Development Services

Final Report - Approved

Application No. PL8810

PADRE ISLAND NO 2, BLOCK 43 LOTS 14A, 15A AND 15B

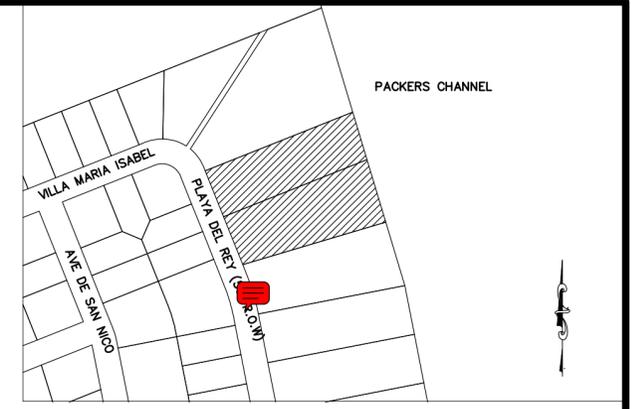
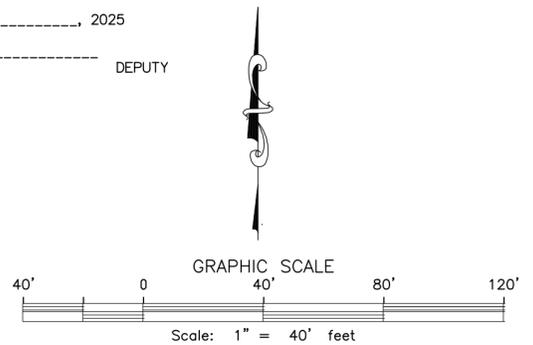
Comment ID	Page Reference	Annotation Type	Author : Department	Status	Review Comments
5	P002	Note	Alex Harmon : DS	Closed	7/16/25 UPDATE: Comment not addressed. Plat has zone AE (10 ft) and Zone AE (11 ft). Utility Plan has zone AE (11 ft) only. Confirm BFEs and ensure consistency.
6	P002	Note	Mark Zans : LD	Closed	Place square footages of lots on the lots.

Comment ID	Page Reference	Annotation Type	Author : Department	Status	Review Comments
7	P002	Note	Mark Zans : LD	Closed	Make plat outline a heavier darker line width. make it distinctive from the other plat lines.
8	P002	Note	Mark Zans : LD	Closed	Park fee: 3 residential units x 462.50 = \$1,387.50
9	P002	Note	Mark Zans : LD	Closed	: Plat is a (Non-public notice PC plat).
10	P002	Note	Mark Zans : LD	Closed	
11	P002	Note	Mark Zans : LD	Closed	The plat will be recommended as Conditional Approval for Resolution comments received and that have remained Open and unmet.
12	P002	Note	Mark Zans : LD	Closed	: A request or response may be made for an additional 30 days for Public Notice plat with a Waiver or to resolve Open comments. This request must be made directly to Development Services within the 30-day initial period.
